Comparison Table Showing the Differences Between the Proposed Scheme and the Approved
Scheme under Application No. A/YL-TT/645

Compliance with Approval Conditions (a) and (c) Planning Application No. A/YL-TT/645

**Proposed Temporary Warehouse for Storage of Construction Materials for a Period of 3 Years
and Associated Filling of Land in "Agriculture" Zone,
Various Lots in D.D. 117 and adjoining Government Land, Tai Tong, Yuen Long, New Territories**

(S.16 Planning Application No. A/YL-TT/645)

DWG. TITLE
LAYOUT PLAN

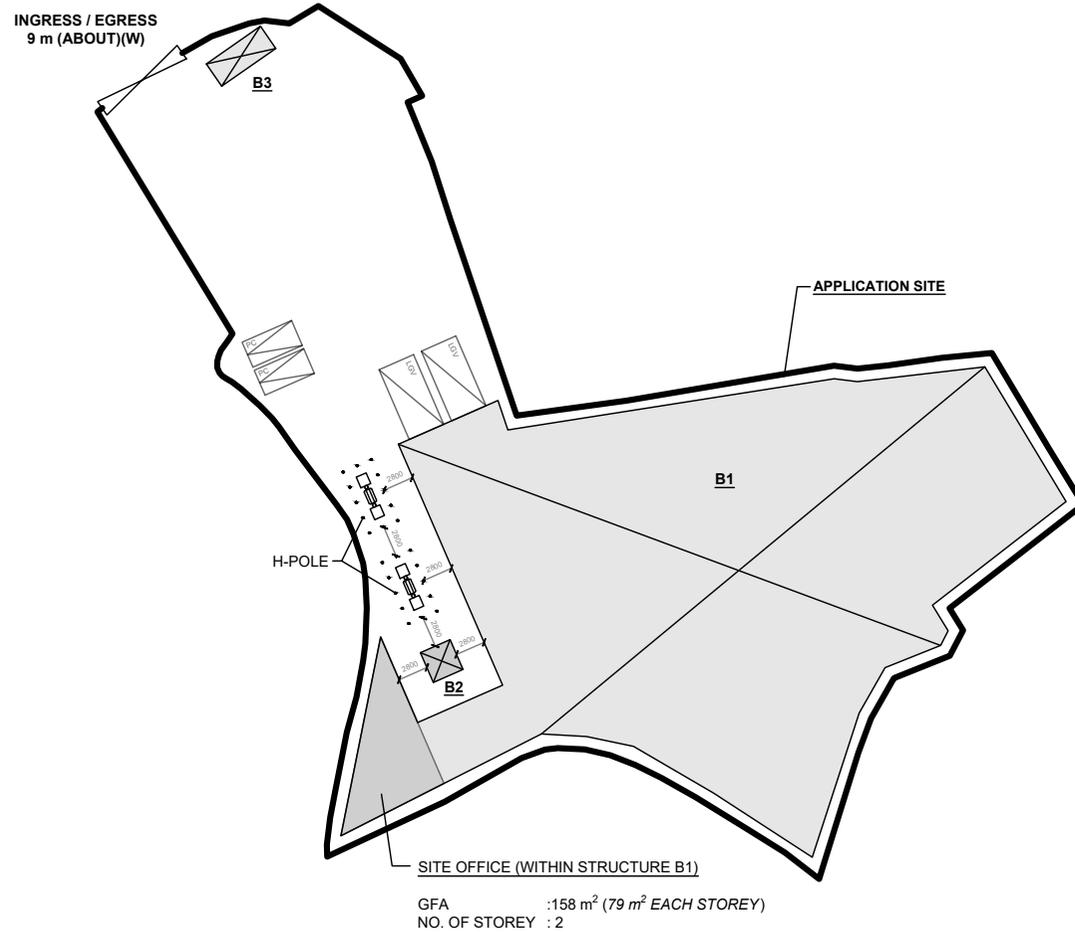
According to the submissions, it is noted that the layout plan has been updated from 1 loading/unloading space for container vehicle into 2 loading/unloading spaces for LGVs. Container vehicles are no longer required to access the local track road.
